S204-08

MODEL
2000-02 MY S-TYPE

Clunk From Front Stabilizer Bar - Revised Design Bushings - Installation Procedure

BRACKET IDENTIFICATION

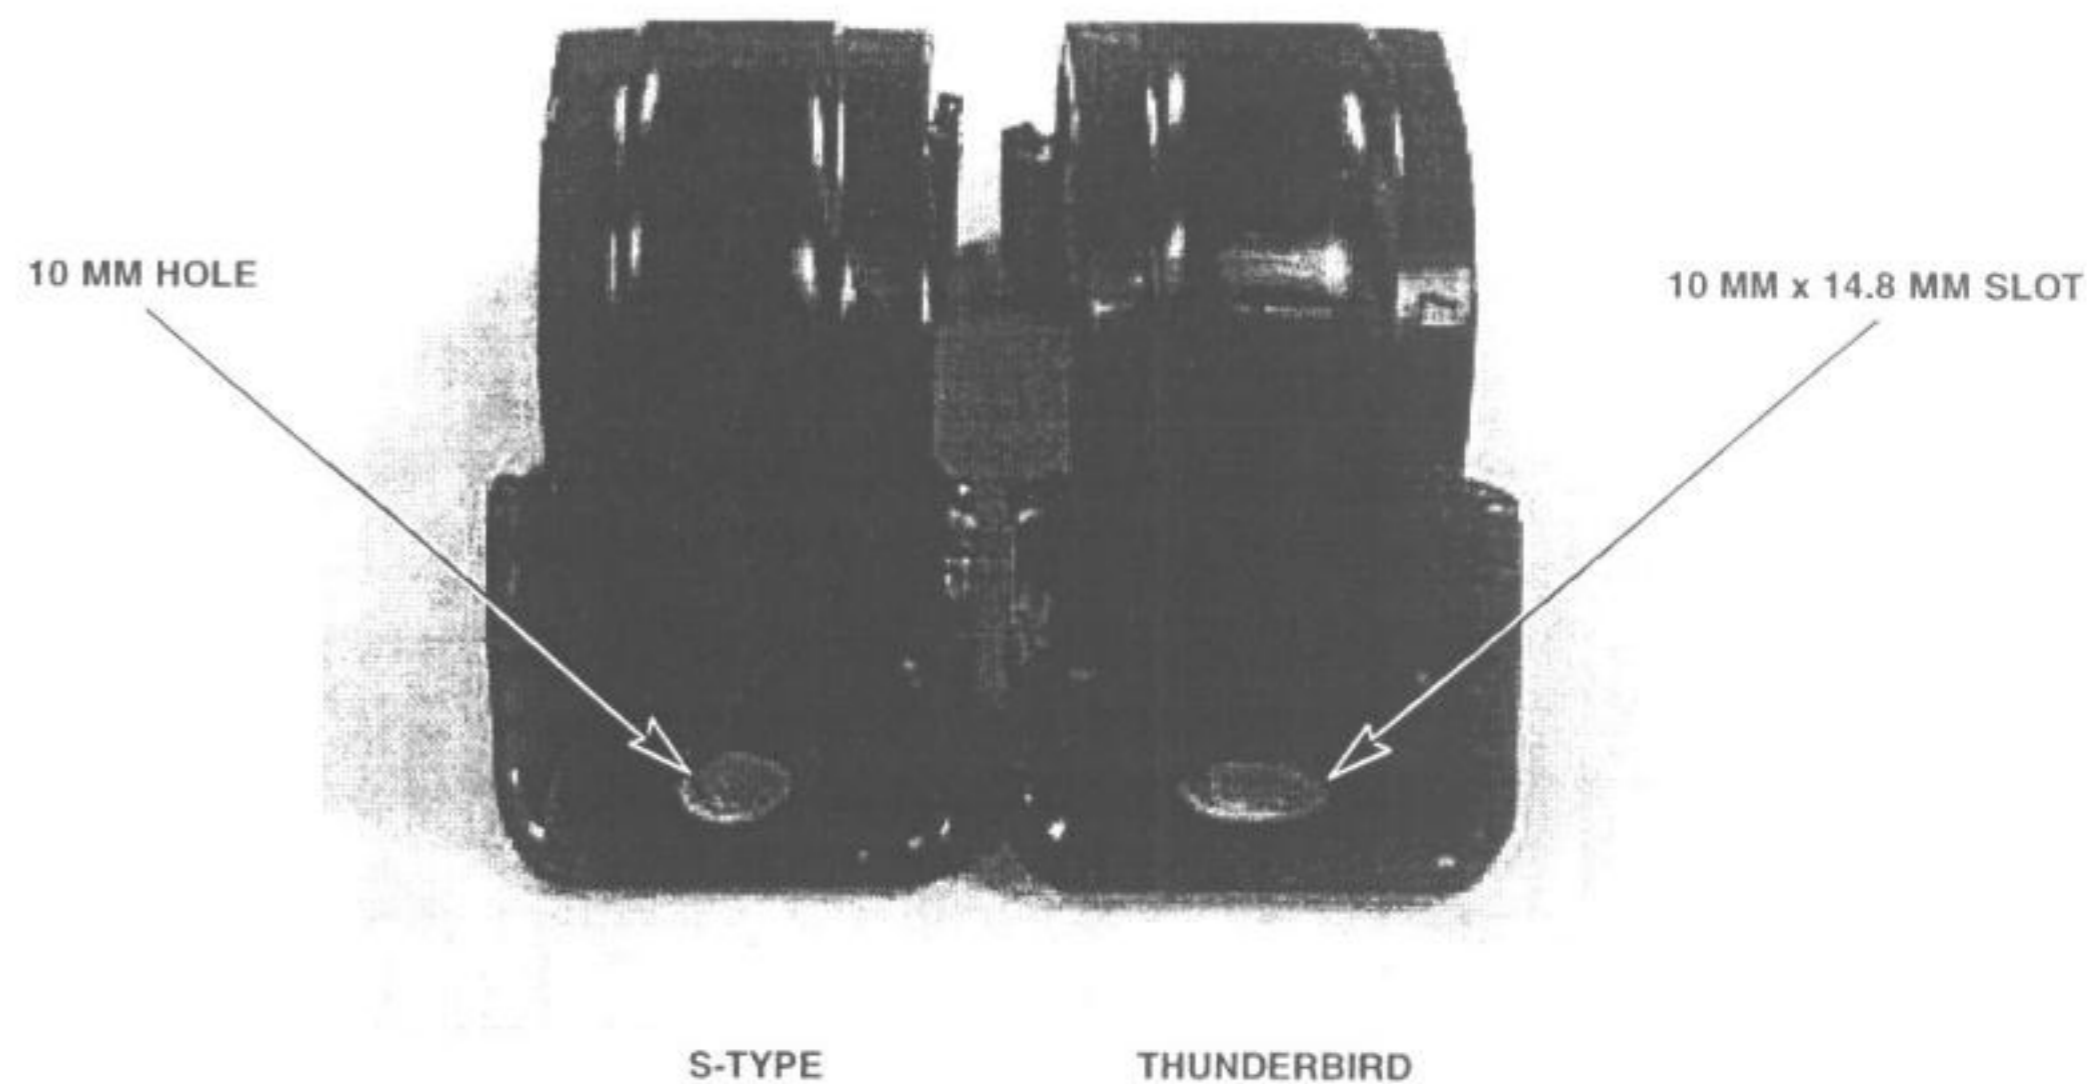
On vehicles up to VIN M39727, inspect the mounting brackets to ensure the vehicle is equipped with the correct specification brackets. Due to a supplier error, Thunderbird mounting brackets may have been installed. The S-TYPE bracket has a 10 mm clearance mounting hole, compared with a 10 x 14.8 mm mounting slot in the Thunderbird bracket (Illustration 1). The Jaguar bracket has an overall hoop height of 55 mm compared with 56 mm for the Thunderbird bracket and the Jaguar material is 1 mm thinner than the Thunderbird bracket. The incorrect bracket will reduce the effective clamping load on the bushing resulting in premature bushing failure. Replace any incorrect brackets with part no. XR8 1834.
